## REVISED RESPONSE TO REQUEST FOR ADDITIONAL INFORMATION

### APR1400 Design Certification

Docket No. 52-046

**RAI No.:** 274-8277  
**SRP Section:** 07.01 - Instrumentation and Controls - Introduction  
**Application Section:** Section 7.1, 7.3, and 10.2  
**Date of RAI Issue:** 10/27/2015

Figure 7.3-23 Radiation Monitoring System Measurement Channel Functional Diagram

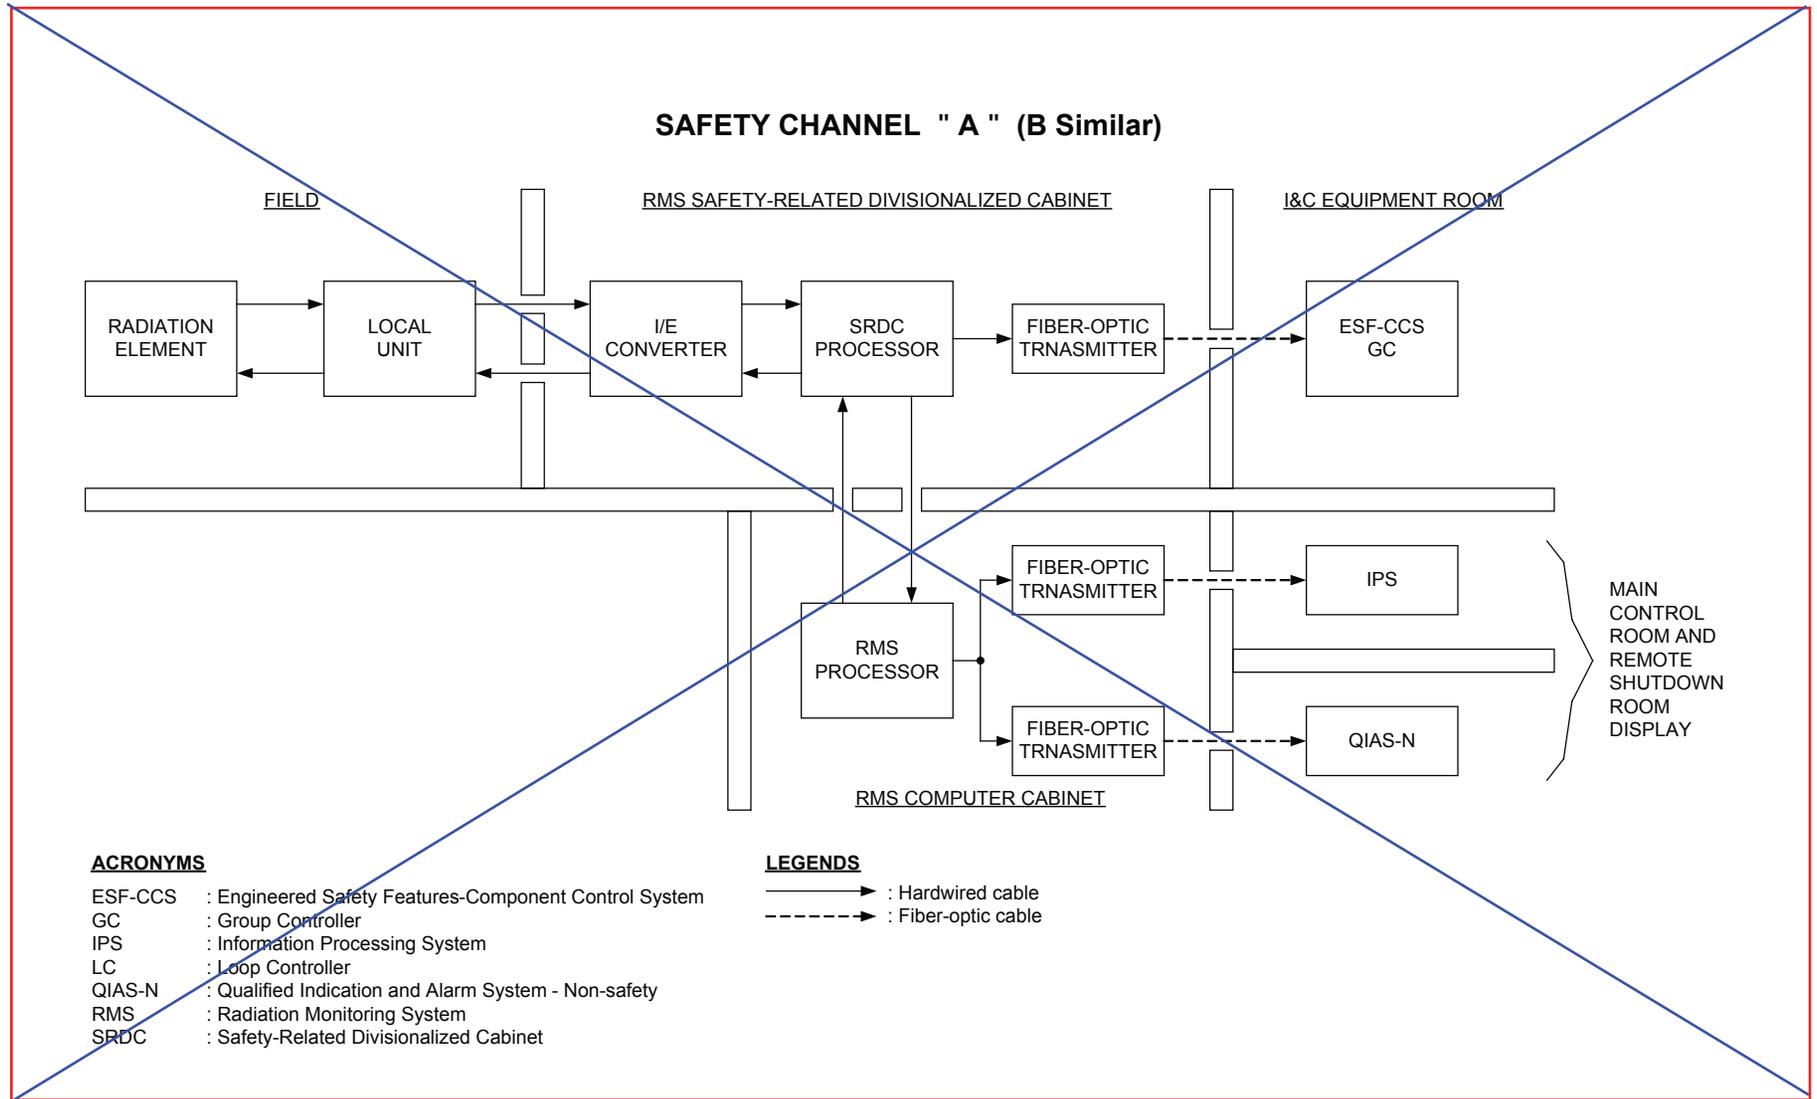
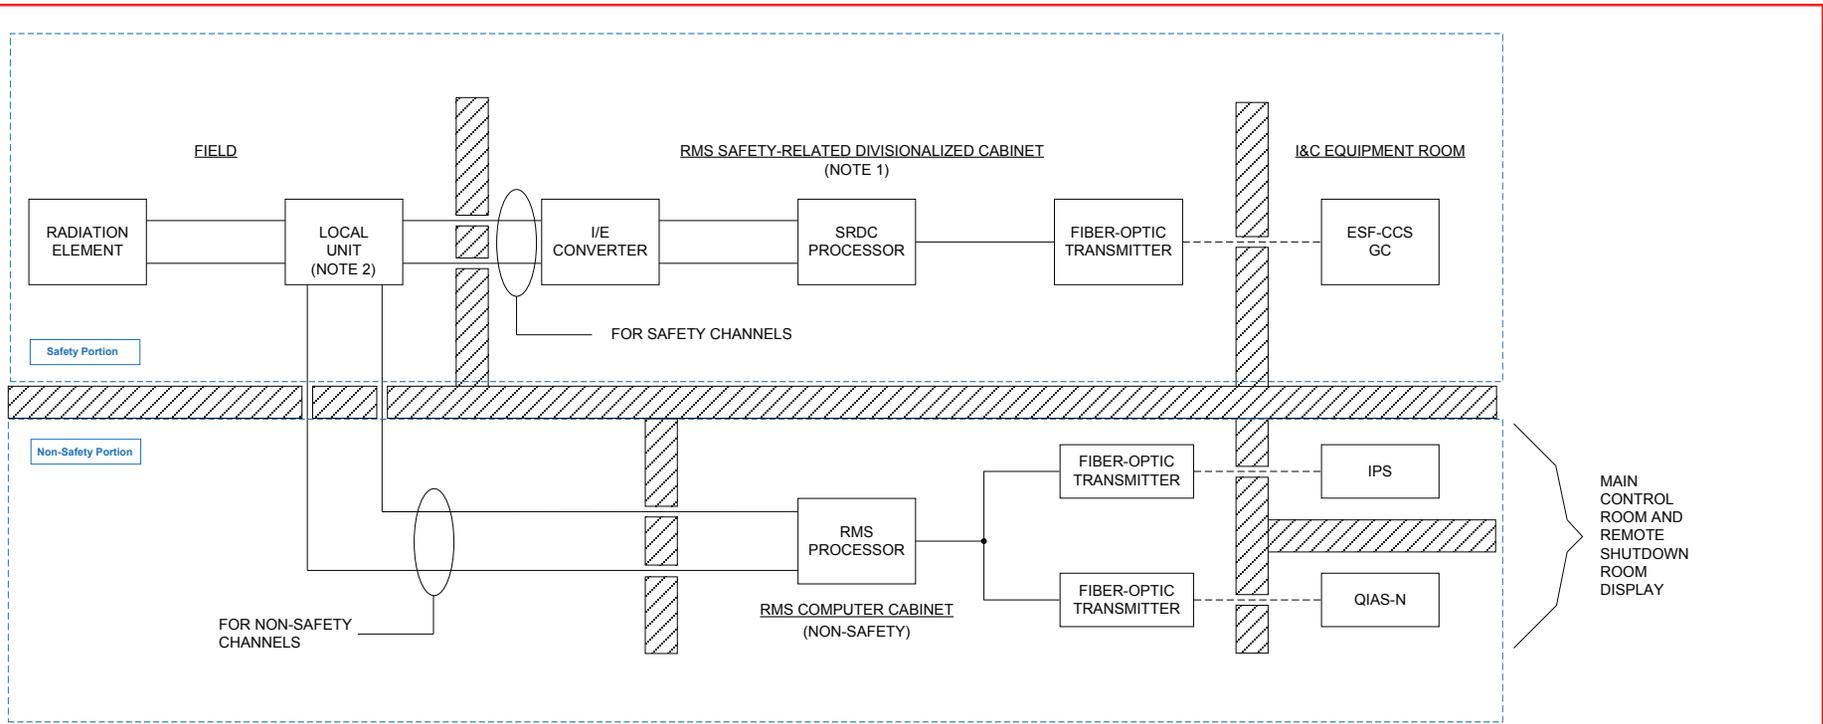
- a. APR1400 FSAR Tier 2, Section 7.3.1.1, states the balance of plant (BOP) ESFAS receives process variable signals from the safety portion of the RMS, manual ESF system-level actuation switches, and manual channel bypass switches. The BOP ESFAS consists of 1-out-of-2 logic taken twice except for the Fuel handling area emergency ventilation actuation signal (FHEVAS), which has one 1-out-of-2 logic. APR1400 FSAR Tier 2, Figure 7.3-23, shows the RMS measurement channel functional diagram, but design descriptions or reference to this figure were not provided in FSAR Tier 2, Section 7.3. Based on this figure, it is not clear how many divisions are in the RMS SRDC. In addition, it is not clear whether the RMS computer cabinet is safety-related or non-safety. If the RMS processor in the computer cabinet is non-safety, then how is it isolated from the SRDC processor to meet the independence requirements of IEEE Std. 603-1991, Clause 5.6.3? If the RMS processor is safety-related, how is it meeting independence requirements of IEEE Std. 603-1991, Clause 5.6.3 when transmitting information to the IPS and QIAS-N?

- a. DCD Tier 2, Section 7.3.1.1 will be revised to provide a detailed design description and reference to Figure 7.3-23.

Figure 7.3-23 is to be revised to reflect the latest system functional configuration. The radiation monitoring system (RMS) processor receives the electrically isolated radioactivity measurement signal directly from the local unit, rather than from the safety related divisionalized cabinet (SRDC) processor.

The revised figure is a simplified block diagram which provides a functional overview of the RMS. Although the number of divisions for the SRDC can be inferred from the previous heading written above the SRDC, where it states "safety channel 'A' (B similar)," a note has been added to clearly state the SRDC cabinet has redundant

The RMS computer cabinet is non-safety related; Figure 7.3-23 is to be revised accordingly for clarity. Those measurement signals originating from the safety related detector channels that are transmitted to the non-safety RMS processor are electrically isolated using an IEEE Std 384 Class 1E qualified isolator per Clause 6.2.2, at each local unit. This satisfies the independence requirement between safety systems and other systems per IEEE Std 603-1991, Clause 5.6.3.

Since the isolation is done at the local unit, no isolation is needed for those signals sent to the IPS and QIAS-N. The revision to Figure 7.3-23 shows the connection from the RMS processor to the IPS and QIAS-N through a fiber-optic converter. The fiber-optic converter does not provide isolation, but provides data communication paths via fiber-optic signal transmission.

Replace this figure with attached figure A.

1. THE SRDC CABINET IS REDUNDANT,HAVING DIVISIONS A AND B.
2. ISOLATORS ARE INCLUDED.
